# Documentation: VRU-Proxi-30-02 (OICA) R158\_OICA Proposal.

## VRU-Proxi-30-02 (OICA) R158\_OICA Proposal

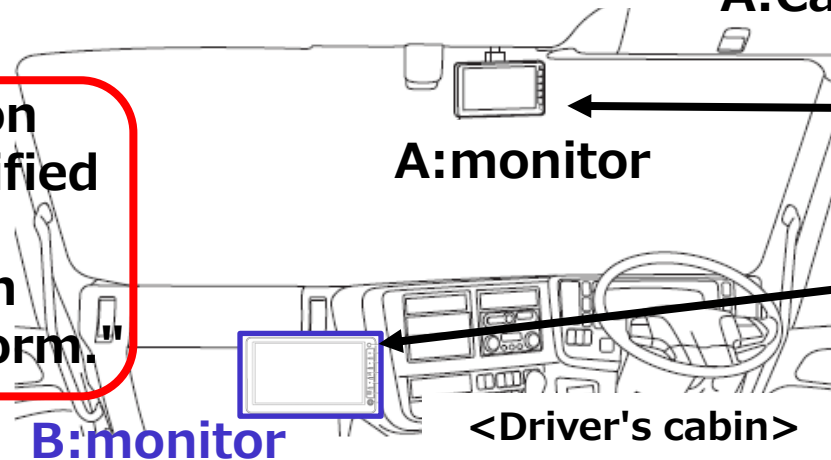
- 1- When retreating without a loading platform, **A:Camera** and **A:Monitor** provide rear view information to the driver
- 2- Equipped with a detachable loading platform and when retreating, **B:Camera** and **B:Monitor** provide additional rearward visibility information to the driver

- Q1: Is the automatic switching between "A:Camera&A:Monitor information" and "B:Camera&B:Monitor information" compatible?
- Q2: With "A:Monitor" and "B:Monitor" as one unit, is the switching display of "A:Monitor Information" and "B:Monitor Information" compatible?

1, When the rear view information by B:Camera satisfies the specified performance of UN-R158, "It complies with this regulation with a detachable loading platform."

A: The video on the monitor is A: Camera information (Visibility performance meets UN-R 158)

B: The monitor's image is B: Camera information (Visibility performance meets UN-R 158)

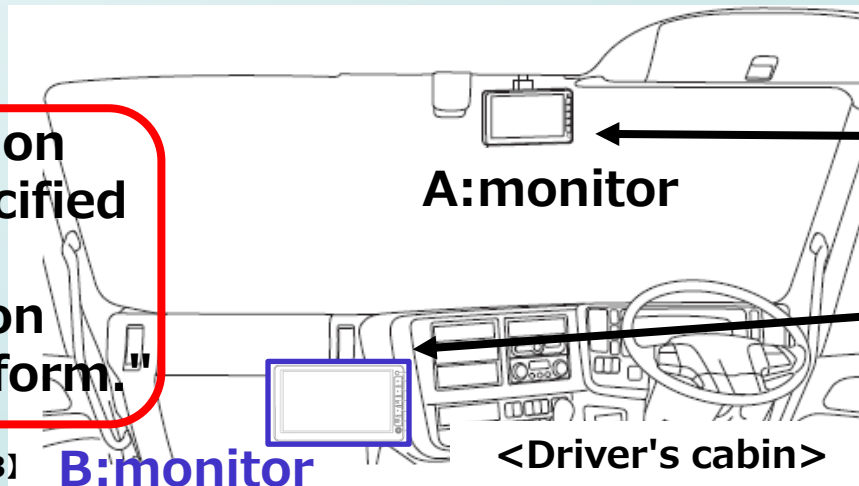
- 1- When retreating without a loading platform, **A:Camera** and **A:Monitor** provide rear view information to the driver
- 2- Equipped with a detachable loading platform and when retreating, **B:Camera** and **B:Monitor** provide additional rearward visibility information to the driver

- Q1: Is the automatic switching between "A:Camera&A:Monitor information" and "B:Camera&B:Monitor information" compatible?
- Q2: With "A:Monitor" and "B:Monitor" as one unit, is the switching display of "A:Monitor Information" and "B:Monitor Information" compatible?

1, When the rear view information by B:Camera satisfies the specified performance of UN-R158, "It complies with this regulation with a detachable loading platform."

**A:** The video on the monitor is A: Camera information  
(Visibility performance meets UN-R 158)

**B:** The monitor's image is B: Camera information  
(Visibility performance meets UN-R 158)

A:Camera

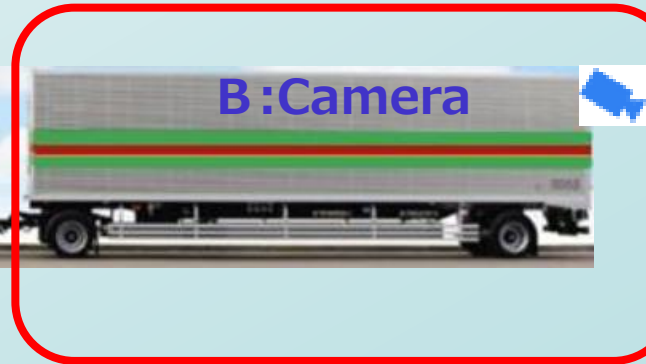
- 1- When retreating without a loading platform, **A:Camera** and **A:Monitor** provide rear view information to the driver
- 2- Equipped with a detachable loading platform and when retreating, **B:Camera** and **B:Monitor** provide additional rearward visibility information to the driver

- Q1: Is the automatic switching between "A:Camera&A:Monitor information" and "B:Camera&B:Monitor information" compatible?
- Q2: With "A:Monitor" and "B:Monitor" as one unit, is the switching display of "A:Monitor Information" and "B:Monitor Information" compatible?
